**HUGHES  
SERVICE INFORMATION  
NOTICE**

NOTICE NO. HN-80

**SUBJECT:** BENDIX SERVICE BULLETIN NO. 109, DATED 10/22/74  
INSPECTION, FLEXIBLE COUPLING LOCKNUTS

# Service Bulletin No. 109

FIGURE 1

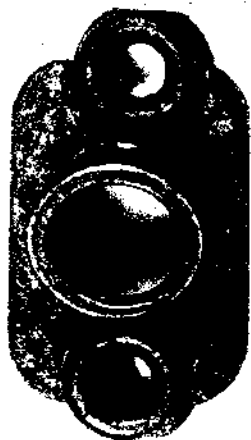
Research of records indicate receipt of one lot of floating nuts as depicted in "B", Figure 1. It is recommended the nuts illustrated in "B", be replaced to preclude cracking. Floating nuts as illustrated in "A", Figure 1, are acceptable and do not require replacing.

Inspect subject shafts and couplings to determine type floating nuts installed. Parts conforming to floating nuts illustrated in "A", Figure 1, do not require replacing.

Parts conforming to "B", Figure 1, inspect for any cracks or indication of cracks in the clinched area of nut.

FIGURE 2

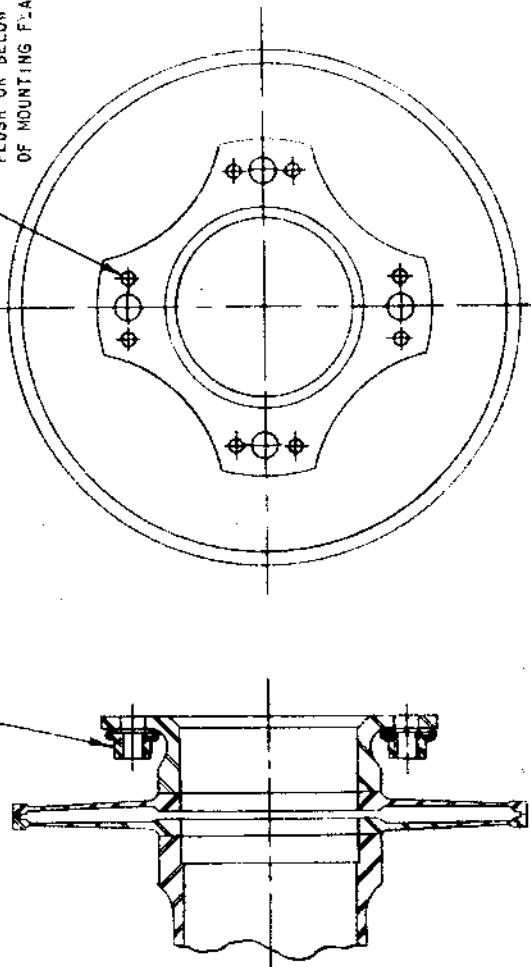
When practical and with availability of riveting tool, reinstall Nut, NAS1068A4, with rivets using proper riveting tool. Rivet heads must be flush or below flange surface. Reference Figure 2.

MS 20605MP3K3  
RIVET HEAD MUST BE  
FLUSH OR BELOW FACE  
OF MOUNTING FLANGE
